December 29, 2025

CONTRACT NO. 1797

OHIO RIVER TUNNEL

ADDENDUM No. 11

- Revised ORT-ST-103 (Sheet 103 of 770)
- Revised ORT-ST-500 (Sheet 152 of 770)

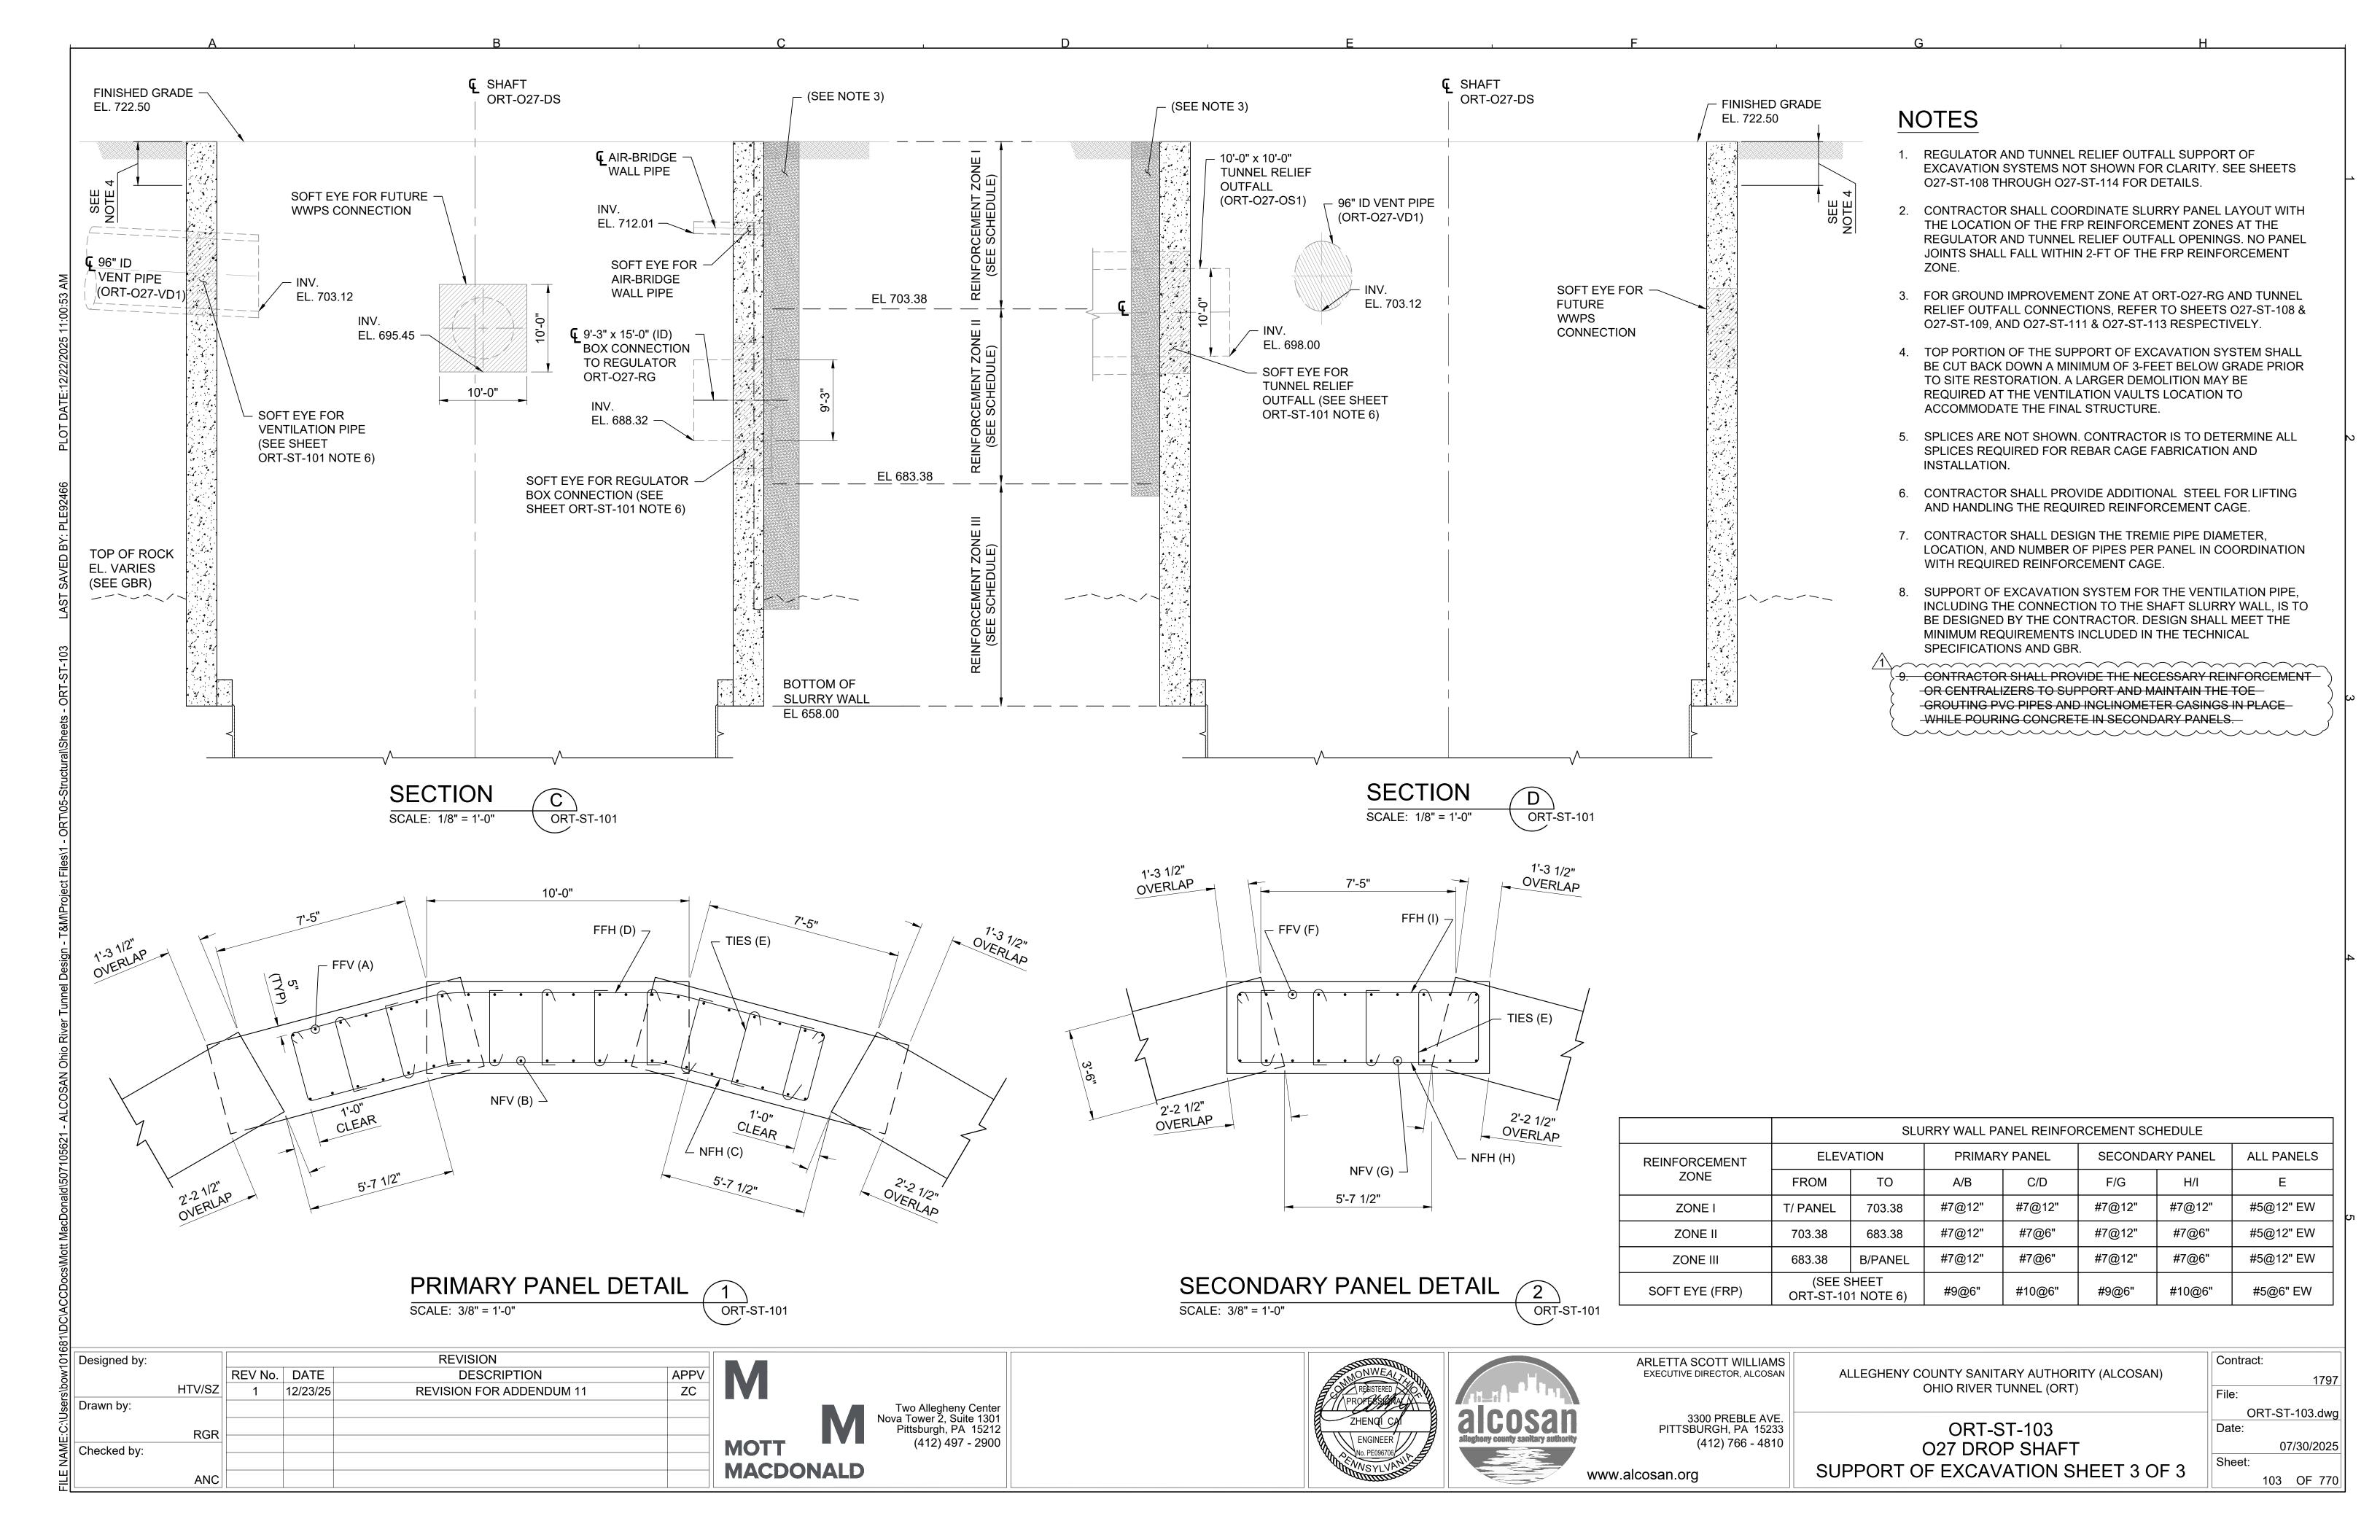
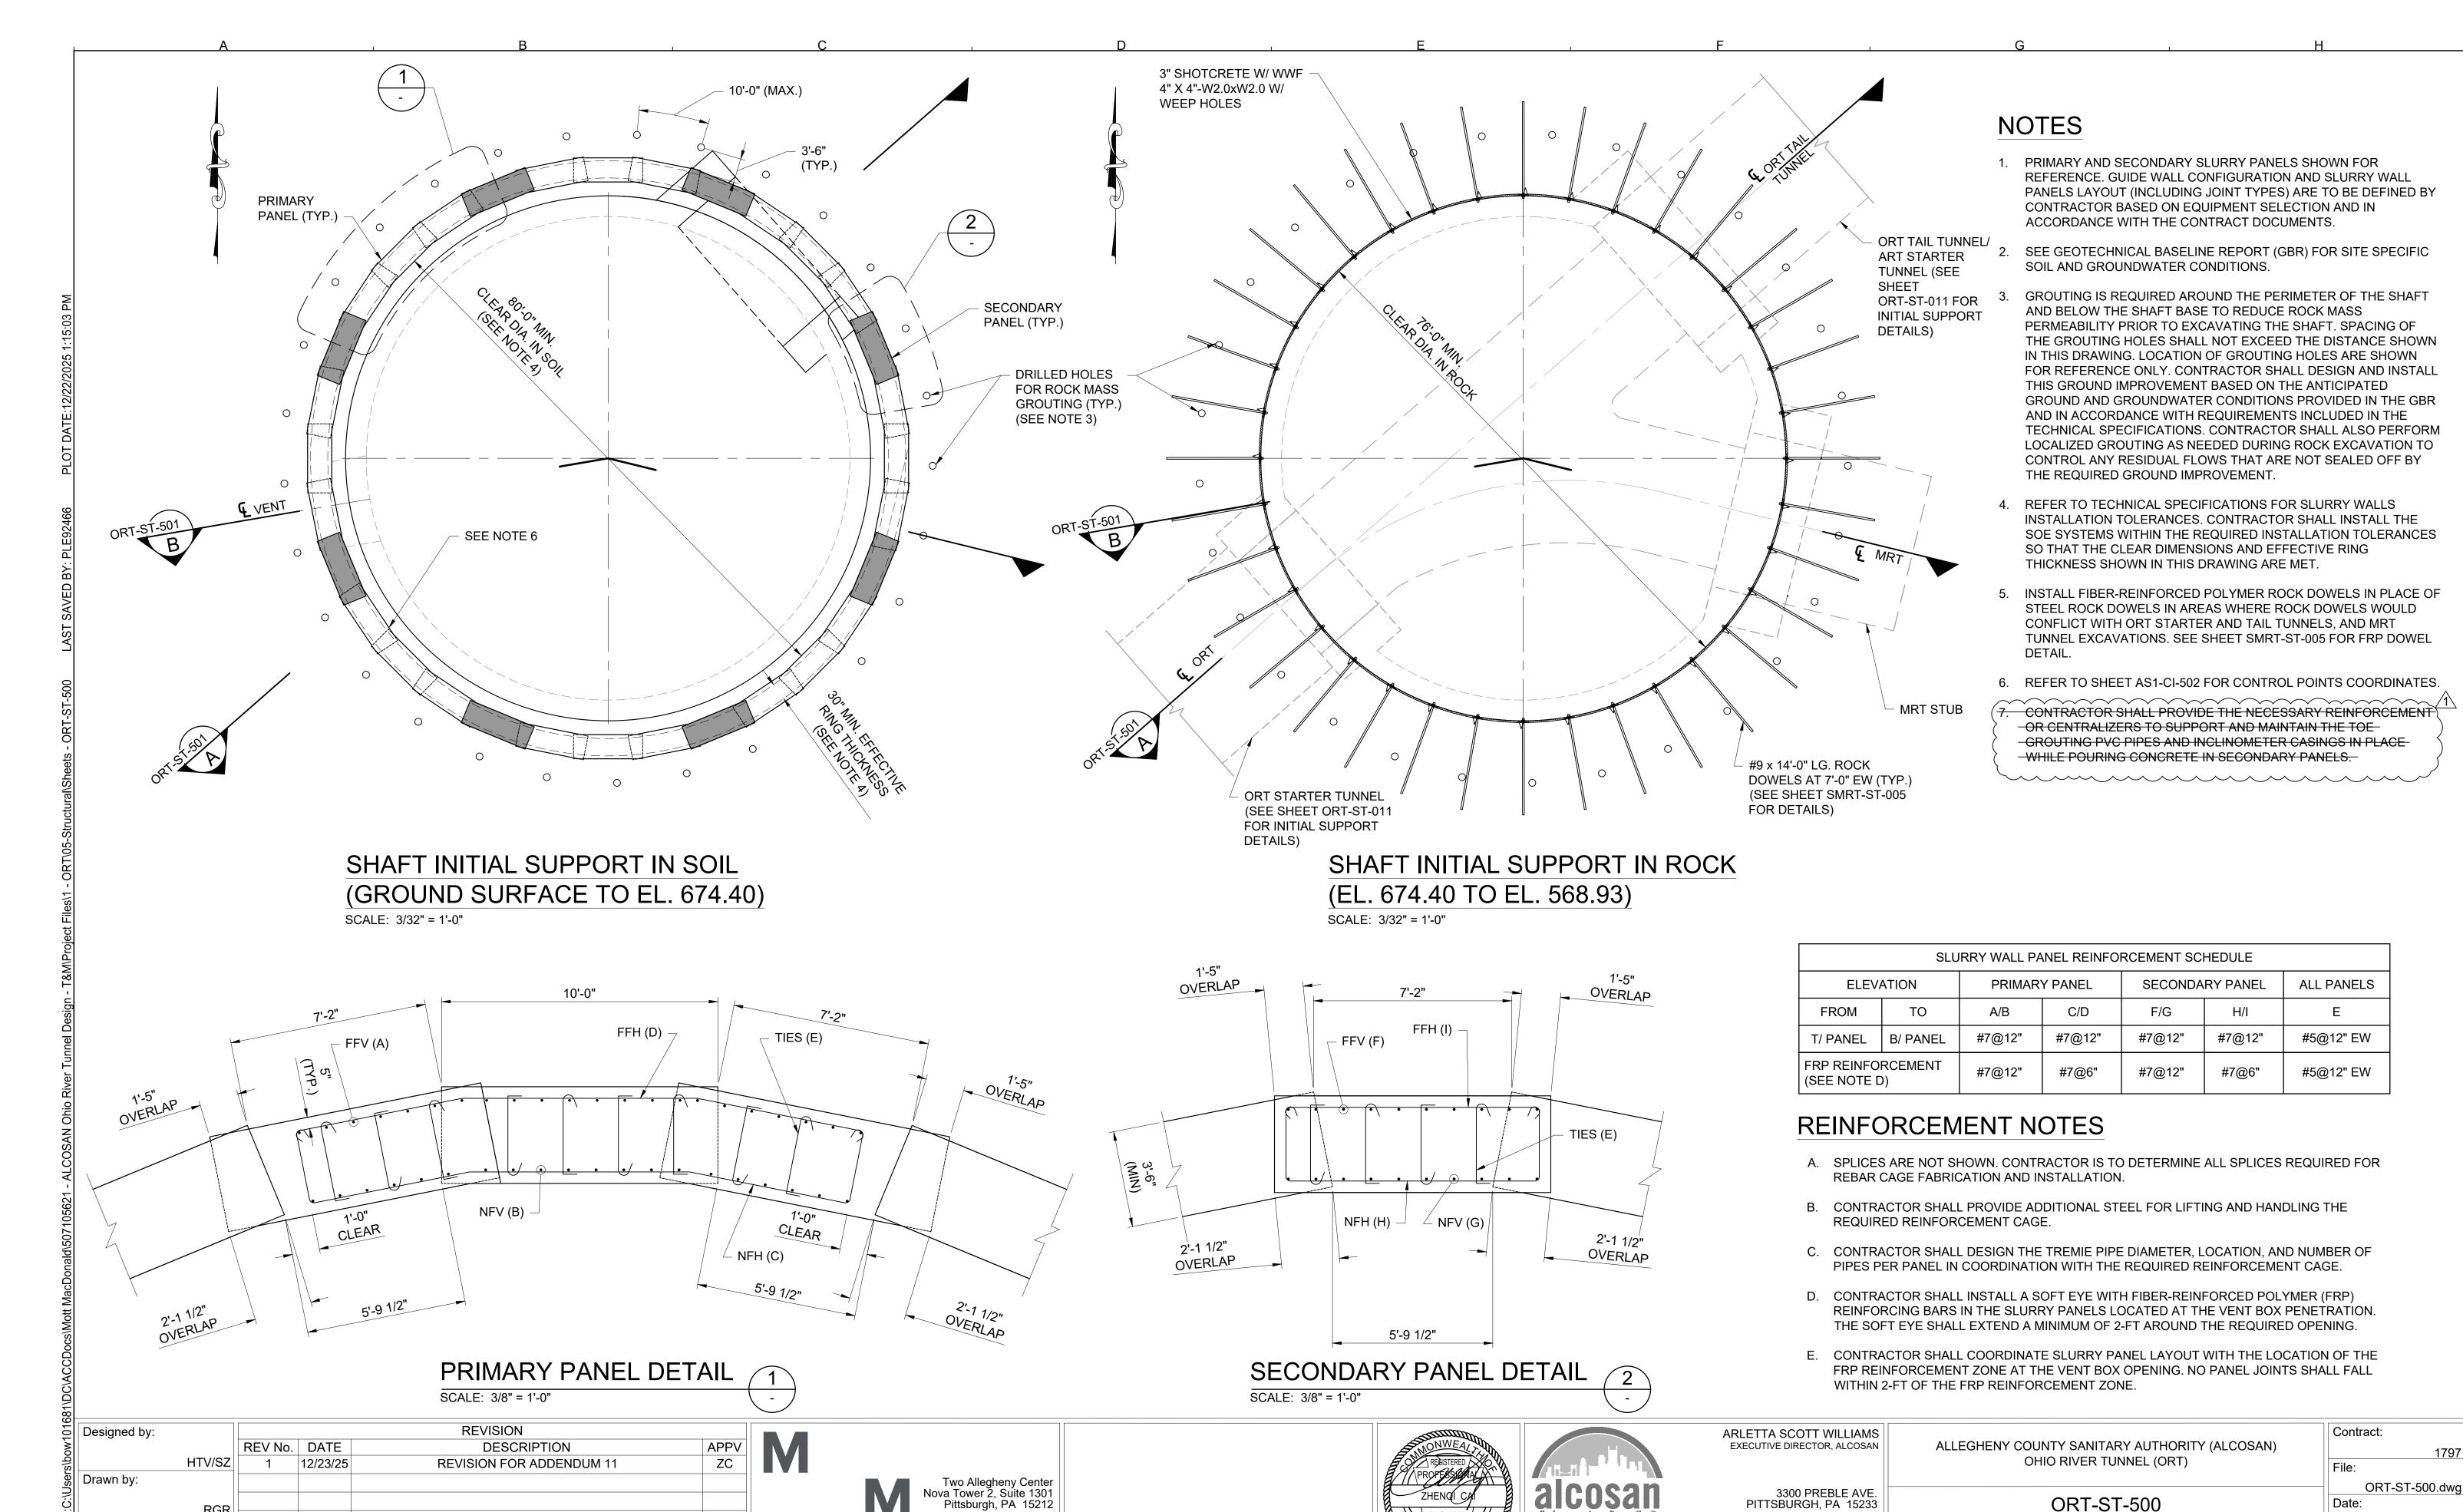
Q37 Drawing ORT-ST-103, Note #9 (Shaft O27) and ORT-ST-500, Note #7 (Shaft AS1) Both of these notes state "CONTRACTOR SHALL PROVIDE THE NECESSARY
REINFORCEMENT OR CENTRALIZERS TO SUPPORT AND MAINTAIN THE TOE
GROUTING PVC PIPES AND INCLINOMETER CASINGS IN PLACE WHILE
POURING CONCRETE IN SECONDARY PANELS."

Question #1: Where on the Drawings are the locations of the Toe Grouting PVC pipes in the Secondary Panels shown?

Question #2: Are there any Toe Grouting PVC pipes required for the Primary Panels? Question #3: Where on the Drawings are the locations of the Inclinometer Casings in the Secondary Panels shown?

A37 Answer to Questions #1 and #2: Note 9 on ORT-ST-103 and Note 7 on ORT-ST-500 have been removed. Also refer to Addendum 009 Q15/A15 for additional information.

ORT-ST-103 and ORT-ST-500 have been revised. See Section B Item 15 and Attachment H for Changes to Contract Documents.
